Western Star Service Bulletin

54-075

Lengthening the Backup Light Harness

Fig. 2, New Light Switch Jumper Harness

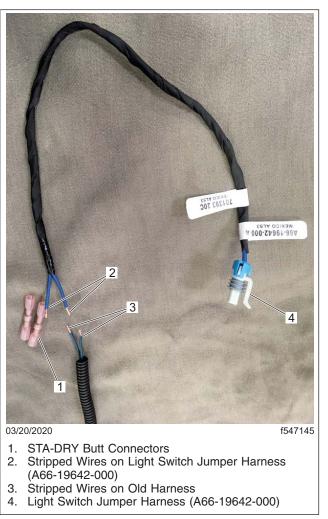
4. Cut off the backup harness connector where the wires enter the connector. See Fig. 2.

5. Connect the new jumper harness (A66-19642-000) using two STA-DRY butt connectors (PHM 1 1863). See Fig. 3.
